Access Compliance Report Public Rights-of-Way (Pedestrian Signals)

Main Street: SIENNA_PKWY Cross Street: CROWN_VALLEY_PKWY Location: SW

ADA ID: SGRK211022120403 Signal Type: One Push Button-Non APS Overall Compliance: No Severity Scores: BTN 1: 10 BTN 2: N/A No BTN: N/A

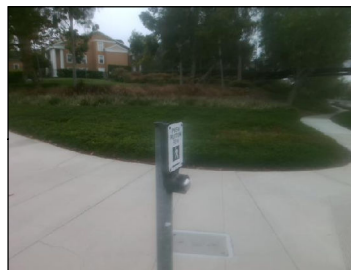
N/A Is Button 1 APS or Non-APS?	NonAPS	N/A Is Button 2 APS or Non-APS?	N/A
N/A B 1 VibroTact Arrow?	N/A	N/A B 2 VibroTact Arrow?	N/A
N/A B 1 VibroTact Parallel to Xing?	N/A	N/A B 2 VibroTact Parallel to Xing?	N/A
N/A B 1 VibroTact Contrast	N/A	N/A B 2 VibroTact Contrast	N/A
No B 1 Pilot Light?	No	N/A B 2 Pilot Light?	N/A
N/A B 1 Pilot Light Illumination?	N/A	N/A B 2 Pilot Light Illumination?	N/A
N/A B 1 Walk Indicator Type	N/A	N/A B 2 Walk Indicator Type	N/A
N/A B 1 Walk Indicator Audible?	N/A	N/A B 2 Walk Indicator Audible?	N/A
N/A B 1 Locator Tone?	N/A	N/A B 2 Locator Tone?	N/A
N/A B 1 Tone Audible Range?	N/A	N/A B 2 Tone Audible Range?	N/A
B 1 Addl APS Features?	No	B 2 Addl APS Features?	N/A
B 1 Addl APS Features Notes	N/A	B 2 Addl APS Features Notes	N/A

Possible Solutions: Replace Signal Push Button With APS Button.
